TRANSMITTAL COVER SHEET

DATE: 21 June, 2024
TO: ALL PLAN HOLDERS OF RECORD
FROM: HUNTER SWATEK, AIA, PROJECT MANAGER
PROJECT: RAINBOW CITY RECREATION CENTER
GMC PROJECT NO. ABHM230021
RE: ADDENDUM NO. 3 AND
ACKNOWLEDGEMENT OF RECEIPT OF ADDENDUM NO. 3

ADDENDUM NUMBER 03

**PROJECT: RAINBOW CITY RECREATION CENTER
GM&C PROJECT NO. ABHM230021**

JOIST LOADING
 DIAGRAMS

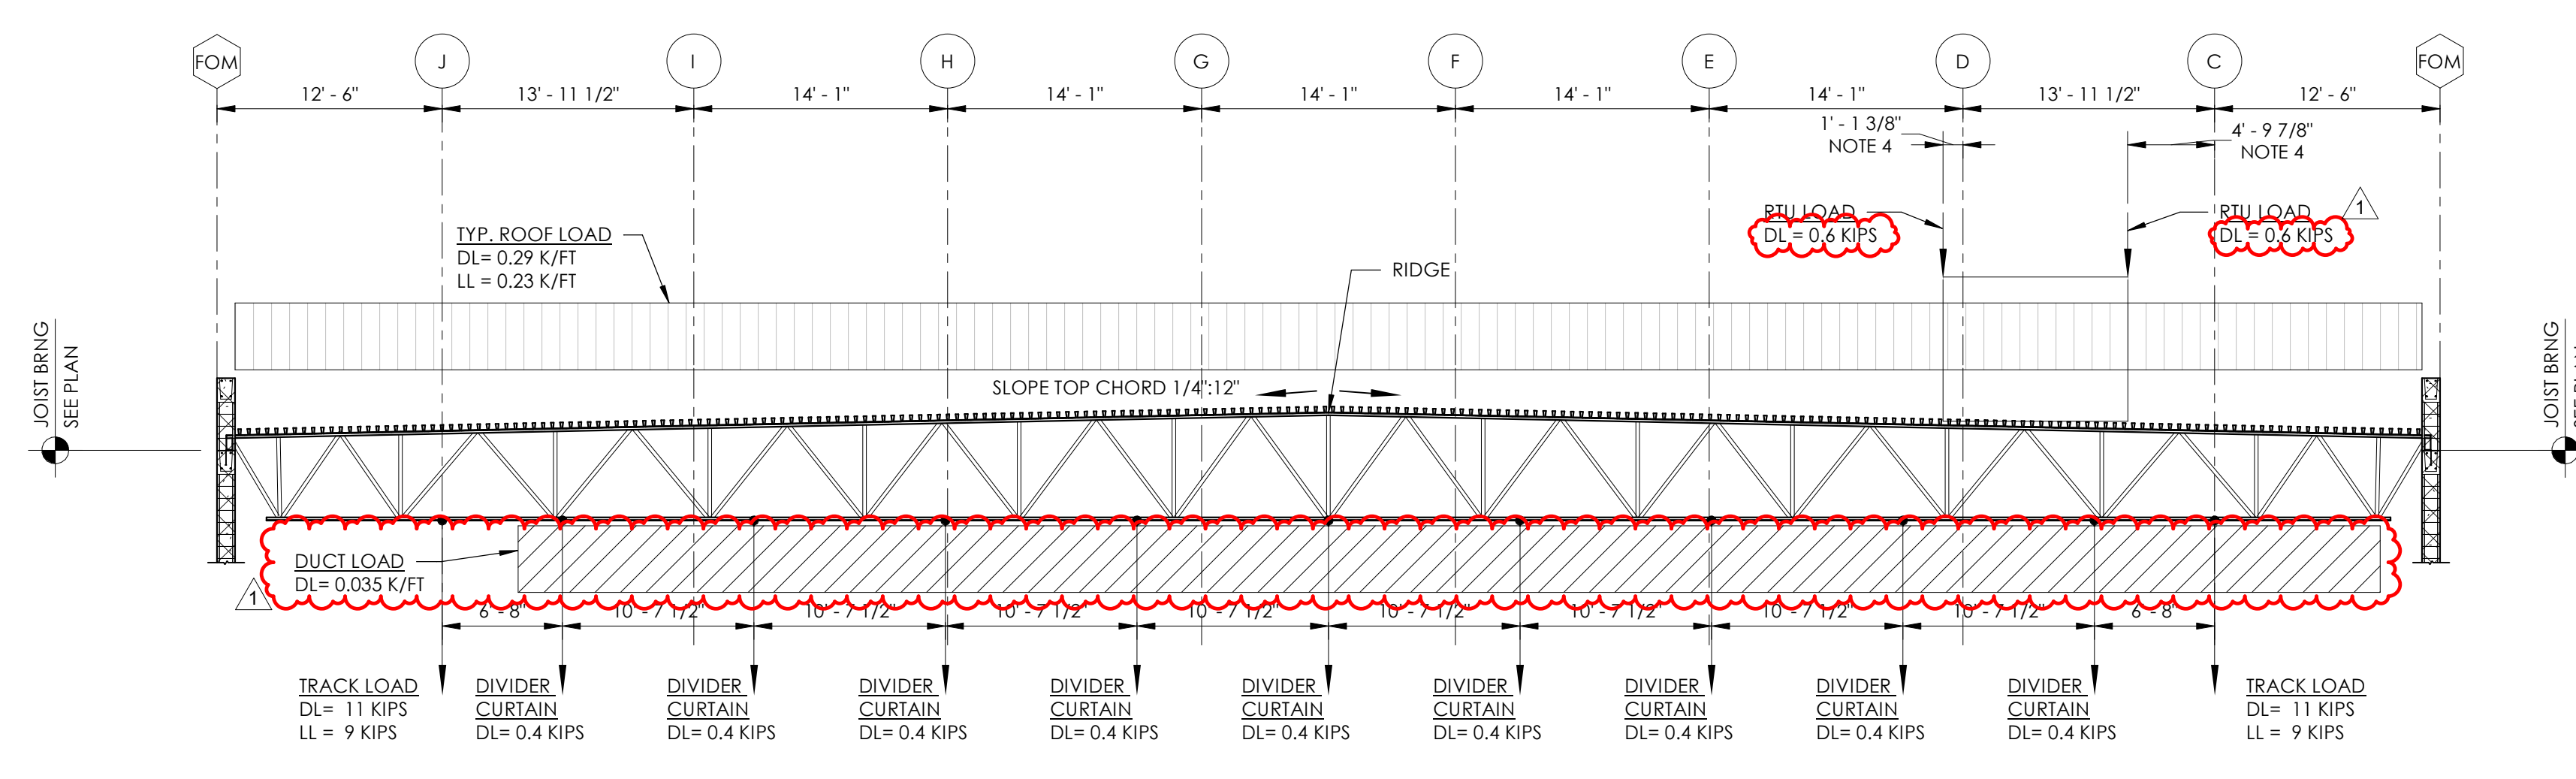
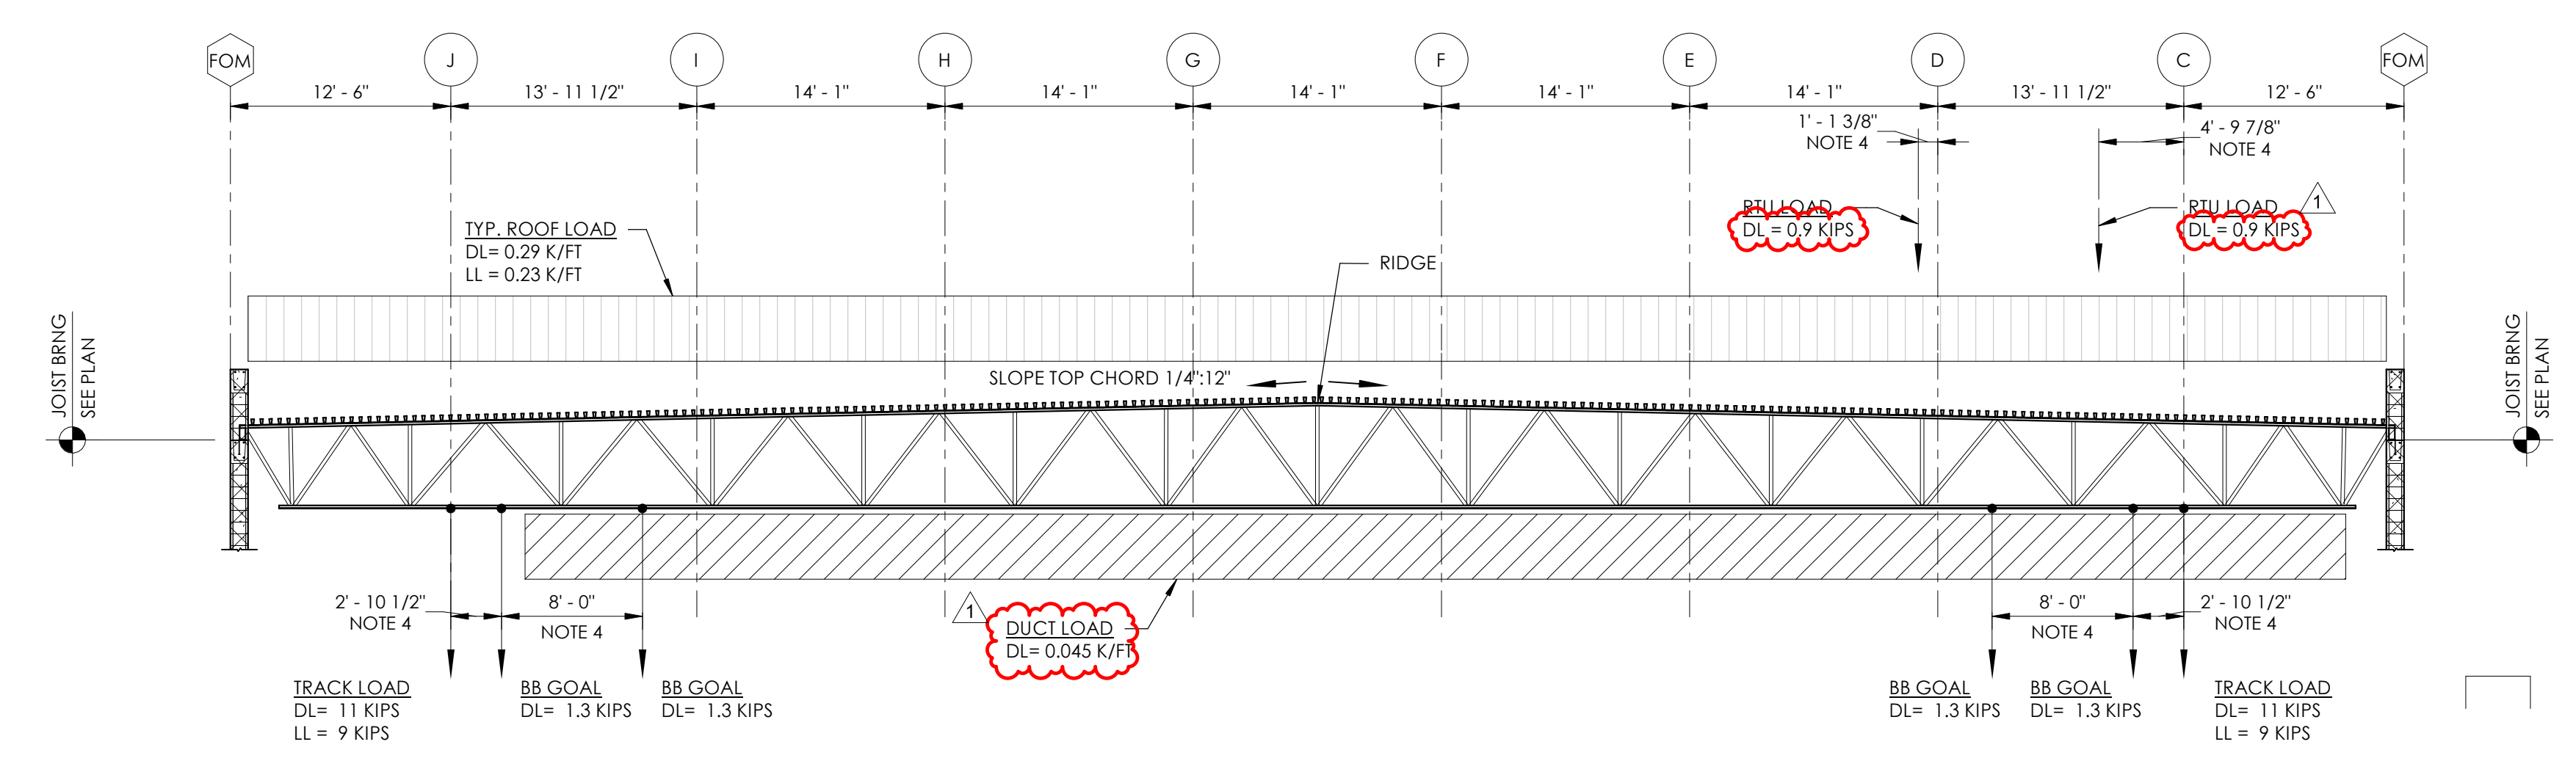
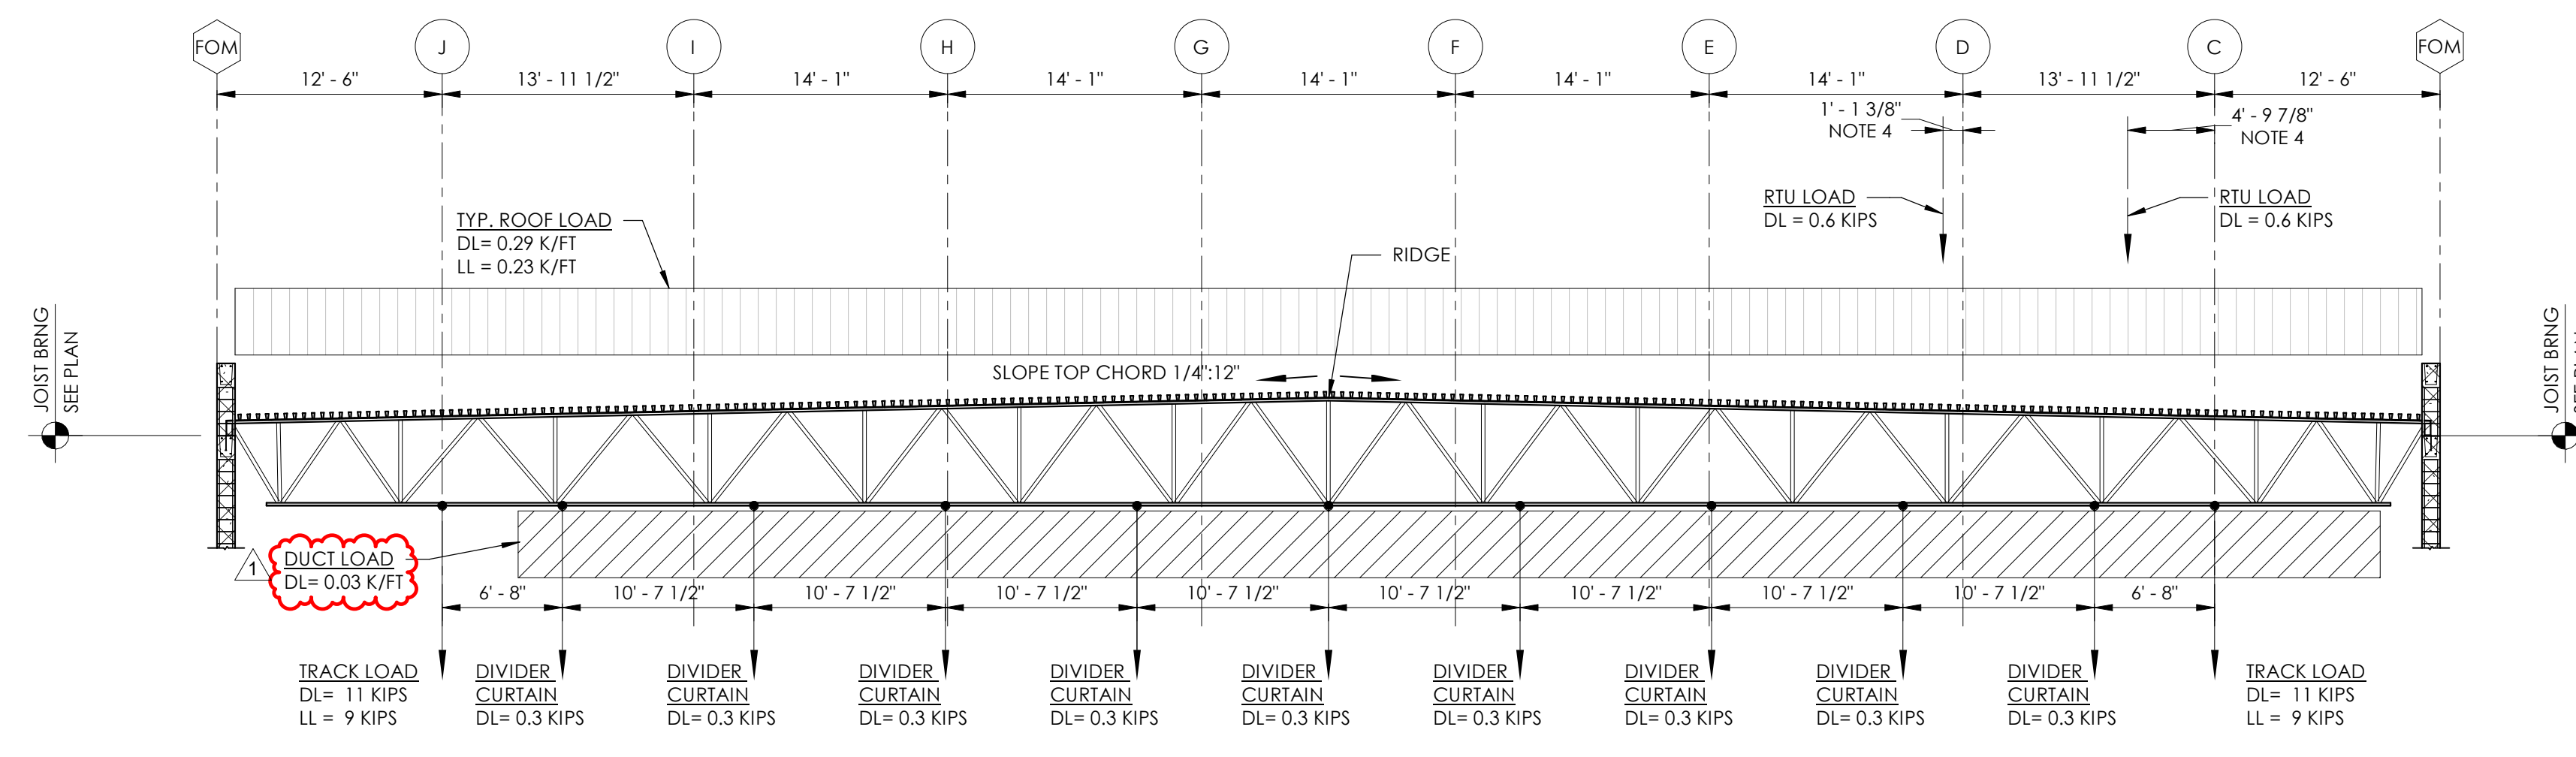
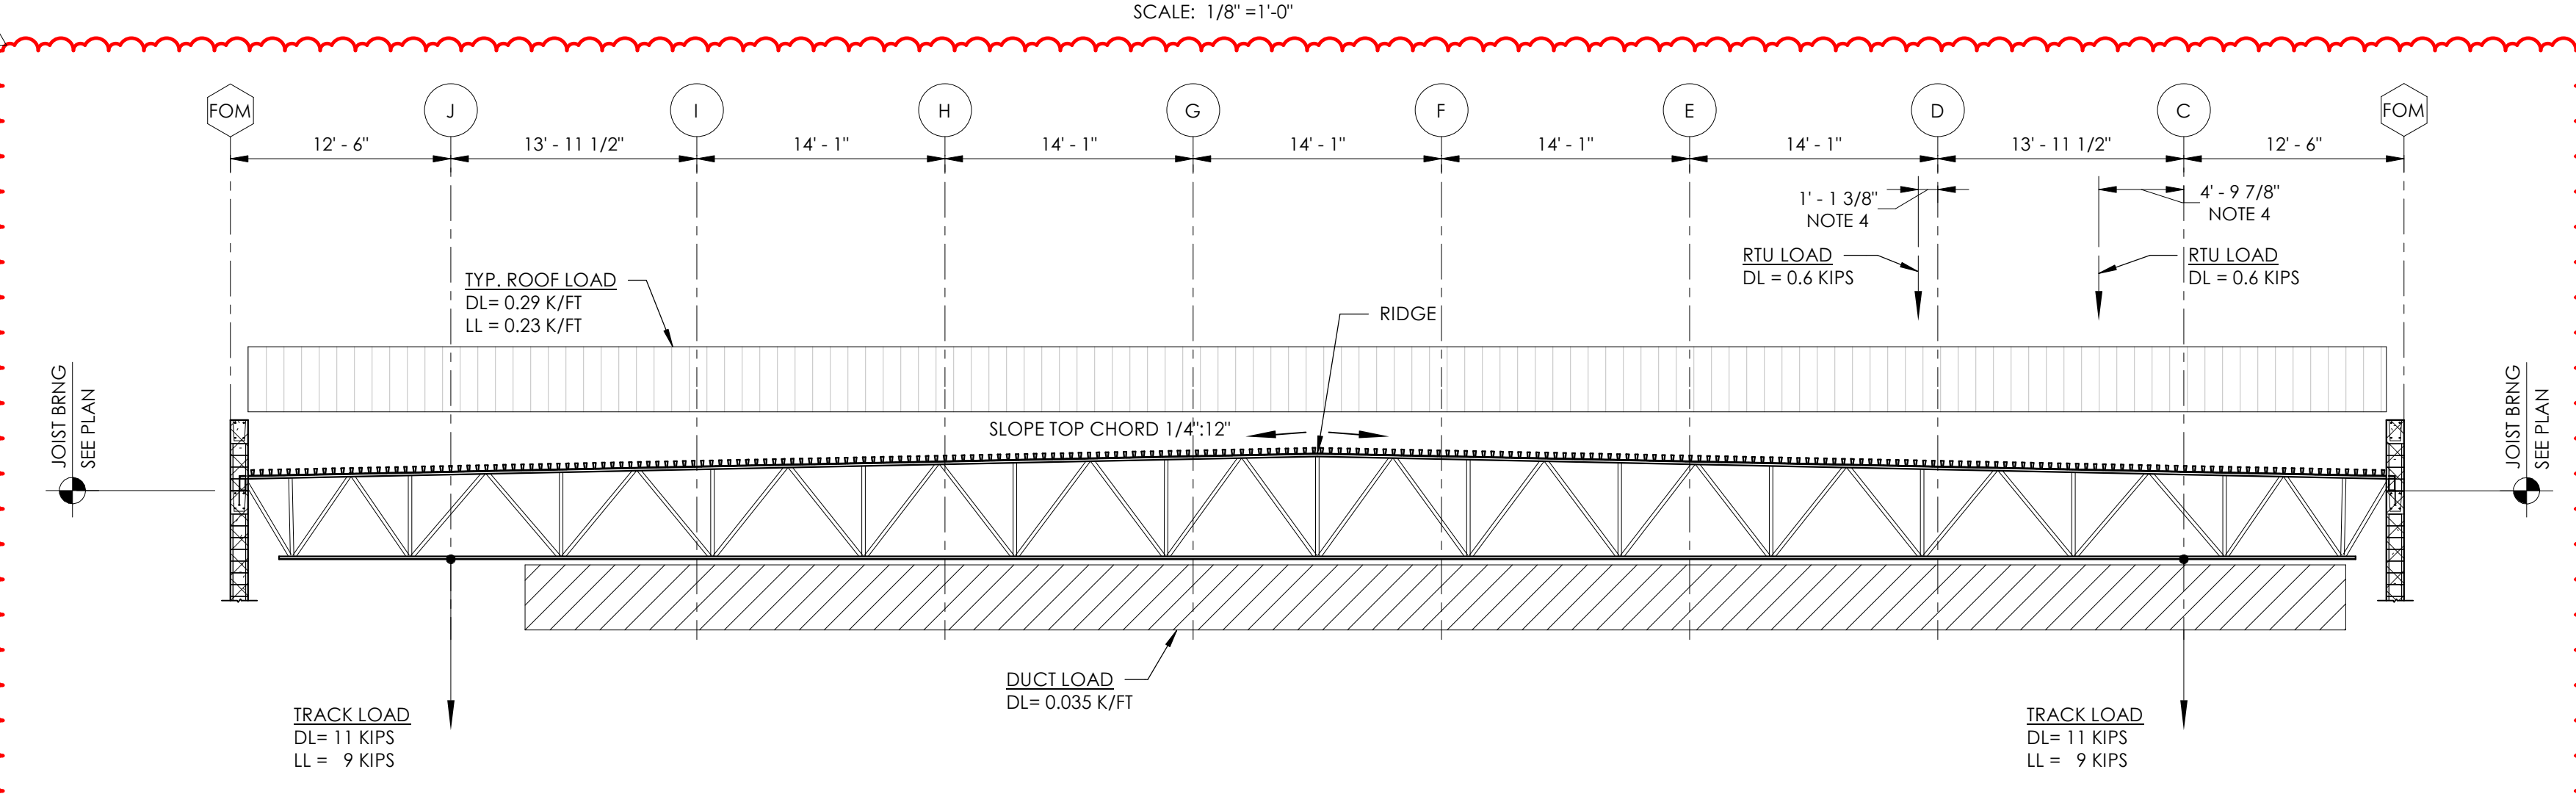
- a. ADDED Details
- R. **S1.01** – Joist Loading Diagrams
 - a. REVISED Loads
- S. **S1.08** – Joist Loading Diagrams
 - a. REVISED Loads
- T. **S2.01** – Floor and Foundation Plan
